**Calvert Cliffs
Nuclear Power Plant**

SUBJECT: Calvert Cliffs Nuclear Power Plant
Unit Nos. 1 & 2; Docket Nos. 50-317 & 50-318
Response to NRC Request for Additional Information Regarding ASME Code
Relief Request to Authorize Use of Mechanical Nozzle Seal Assemblies at
Calvert Cliffs Nuclear Power Plant as an Alternate Repair Method

**RESPONSE TO REQUEST FOR ADDITIONAL INFORMATION
MECHANICAL NOZZLE SEAL ASSEMBLY**

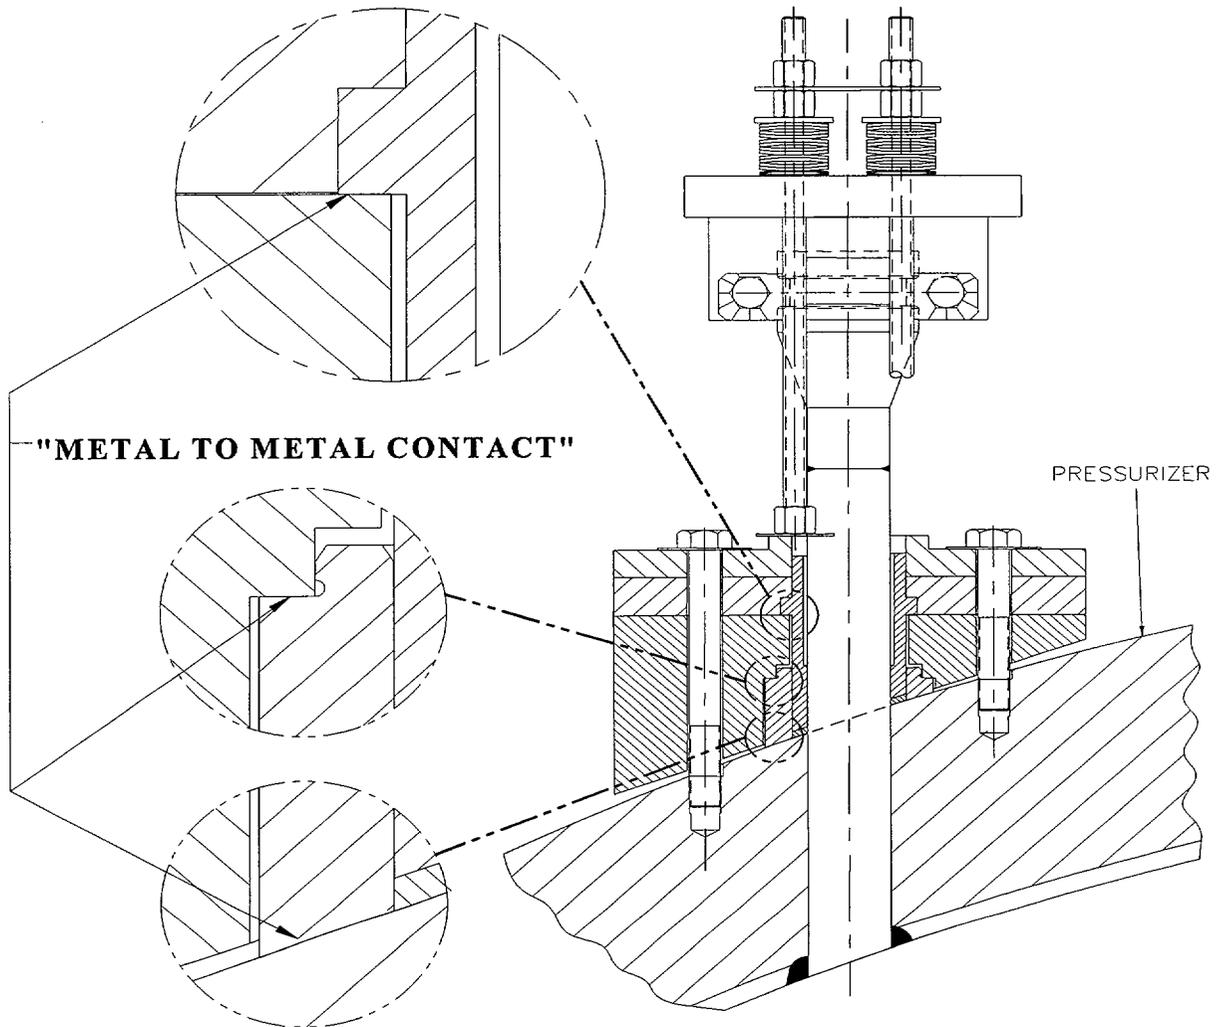
- a. Provide a description, including a diagram, of what is meant by "metal-to-metal."
- b. Provide test data or analysis to support the assertion that "thermal cycling does not work the seal" by showing that the graphite seal experiences zero thermal expansion or contraction under varying thermal conditions.

- a. A detailed schematic of the area of concern is provided below.

- b. The Grafoil seal is captured in a small volume that will not vary except microscopically. The bolt preload maintains the pressure and captures the seal to a nearly constant volume. Similar seals are being used in a variety of applications (valve stem seals) under significantly more thermal volume changes. Grafoil, therefore, can be considered to be a relatively stable seal material, especially when the volume changes are minor. Assuming an annular section of 1/4" (width) x 1/4" (height) x 1.1" (diameter), the volume is computed as $1/4 \times 1/4 \times 3.14 \times 1.1 = 0.215875$ [in³]. Then, assuming an expansion coefficient of $6E-6$ [in/in-Deg], and a temperature differential of 500°F, each dimension changes as follows:

0.250" expands to 0.25075" and
1.100" expands to 1.1033".

The total volume of the Grafoil seal is then 0.2178237 [in³], which equals a percentage change of $(0.2178237-0.215875)/0.215875 \times 100 = 0.9$ [%]. Thus, even neglecting the thermal

expansion of the Grafoil seal, the total volume is well within the initial compression of the Grafoil seal (approximately 35%).
